PLANNING REPORT

Architectural Review Board

72 and 84 N. High Street, 20 North Street 24-145INF

Addresses	72 and 84 N. High Street, 20 North Street, Dublin, OH 43017
Proposal	Informal review and feedback for renovation at three properties in the Historic District. The 0.71-acre site is zoned Historic District-HC, Historic Core, and is located northeast of the intersection of N. High Street and North Street.
Request	Non-binding review and feedback for future development applications.
Zoning	HD-HC, Historic Core District
Planning Recommendation	<u>Consideration of the Discussion Questions</u>
Next Steps	Subsequent to informal review and feedback, the applicant may apply for a Minor Project Review (MPR) with the Architectural Review Board.
Applicant	Stage Capital Partners, Owner Tim Bass, Bass Studio Architects
Case Manager	Sarah Tresouthick Holt, AICP, ASLA , Senior Planner 614.410.4662 sholt@dublin.oh.us

Site Features

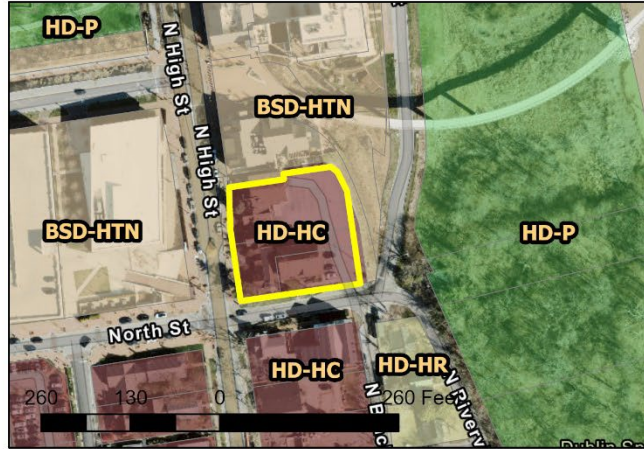
- 1 Historic Gable/Box Bay Window
- 2 Historic Walls
- 3 Stone Arches

Even though the property is Background, Staff believes there are some signature features that should be kept to reinforce District character. These include:

- The gable and box bay window combination on 72 and 84. The northernmost one is original per the 1963 aerial photo (attached) and matches the existing form at North High Brewery, the middle one is a replica, and the southern one is an interpretation of that form. Per initial examination, it appears that the northern box bay is overlain with modern siding; there may be original materials and details underneath that could be exposed, repaired, and copied on the other bays. Staff suspects there may be Stick Style elements/details underneath.

- The historic stone walls on the site. 84 has an original wall and pillar perpendicular to N. High Street, and there are remnants of one parallel to North Street. These are not noted in the HCA; however, historic photos show them.

- The stone arches at the southeast and northeast corners of 20 North Street, which have segmented arch and keystone details. While not historic, they provide interesting pedestrian elements along the right-of-way and use traditional stone.

The Board is requested to confirm the preservation of these signature features, as the project moves into MPR.
